Access Compliance Report

Public Rights-of-Way

Intersection ID: 50638	Main Street: RUBY_VALLEY_RD	Cross Street: BLUE_GROVE_RD	Location: NE
ADA ID: 1525CFA24ABC	Ramp Type: Perp	Initial Pass/Fail: Fail	Overall Compliance: No
Severity Score: 1.25			
Codes/Mitigation Info/Possible Solution		Field Measurements/Component Compliance

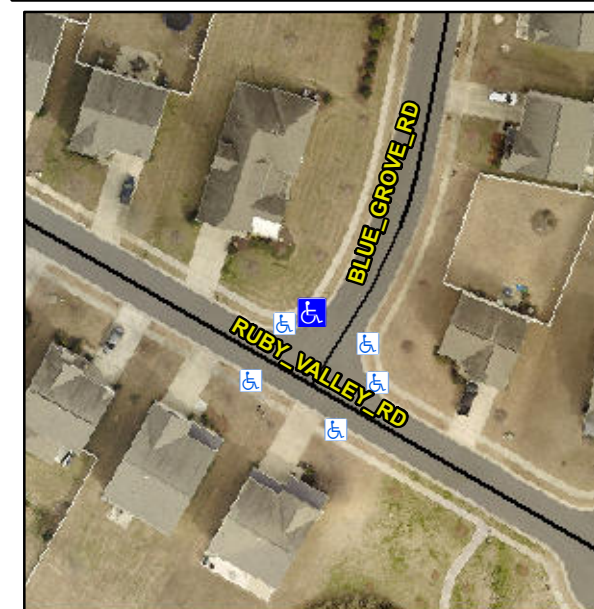
Not Found, R304.5.3

Compliance	Description	Data	Compliance	Description	Data
N/A	Ramp Length (in)	48.0	Yes	Ramp Slope (%)	6.6
Yes	Ramp Width (in)	48.0	No	Ramp XSlope (%)	2.2
N/A	Flare Type LT	N/A	N/A	Flare Type RT	N/A
N/A	Flare Slope LT (%)	N/A	N/A	Flare Slope RT (%)	N/A
N/A	Flare Traversable LT?	N/A	N/A	Flare Traversable RT?	N/A
N/A	Landing Length (in)	N/A	N/A	DWS Provided?	N/A
N/A	Landing Width (in)	N/A	N/A	DWS Contrast?	N/A
N/A	Landing Slope (%)	N/A	N/A	DWS Length (in)	N/A
N/A	Landing X Slope (%)	N/A	N/A	DWS Full Width?	N/A
N/A	Landing Curb? (Y/N)	N/A	N/A	DWS Offset (in)	N/A
N/A	Shared Landing?	N/A			
N/A	Gutter Ponding?	N/A	N/A	Gutter Slope (%)	N/A
N/A	Gutter Lip Ht (in)	N/A	N/A	Gutter X Slope (%)	N/A
N/A	Painted X Walk1?	No	N/A	Painted X Walk2?	N/A
	X Walk 1 Direction	To SE		X Walk 2 Direction	N/A
N/A	X Walk 1 Width (in)	N/A	N/A	X Walk 2 Width (in)	N/A
	X Walk 1 Slope (%)	1.2		X Walk 2 Slope (%)	N/A
	X Walk 1 X Slope (%)	2.1		X Walk 2 X Slope (%)	N/A

Remove & Replace Entire Ramp.
